RE: Sancrox Quarry Expansion Project (SSD-7293) (Port Macquarie-Hastings)

We have reviewed the latest Biodiversity Assessment Report (BAR) prepared by SLR dated May 2021 and have identified several issues in relation to the BAR which are discussed in detail in **Attachment 1** to this letter.

Attachment 1: Detailed BCD Comments – Sancrox Quarry, Port Macquarie

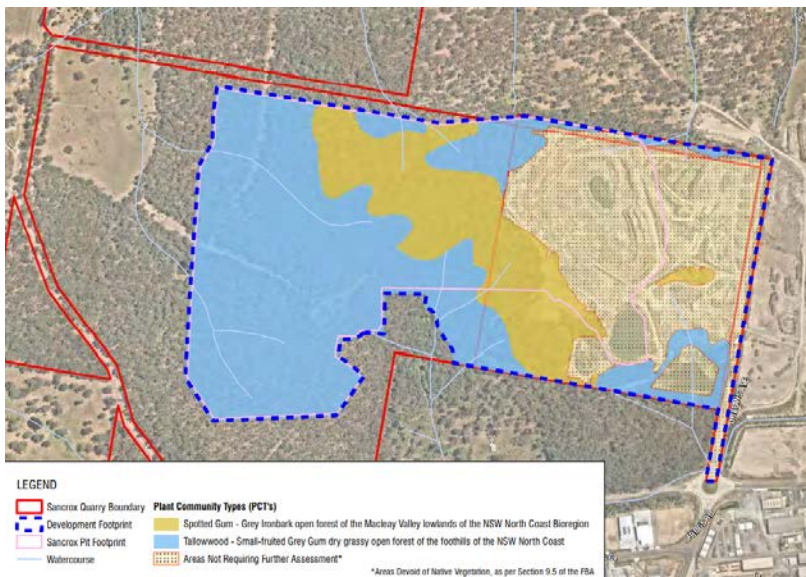
We note that the revised proposal has avoided direct impacts to the previously identified Endangered Ecological Community (EEC). The indirect impacts to this EEC still need to be considered. The revised BAR does not show the location of this EEC and its relationship to the proposed development footprint. The potential indirect impacts on the EEC need to be described within the BAR.

We also note that the proposed development footprint is located on the southern boundary of the subject site and provides no buffer to that property. The biodiversity values of the adjoining property are likely to be similar to those described in the BAR for the proposal. The potential indirect impacts of the proposed development on the biodiversity values of the property to the south need to be considered as part of the BAR. The proposed development footprint as shown in the BAR is detailed below.

5. The indirect impacts of the development have not been considered in accordance with the FBA and further information and justification is required.
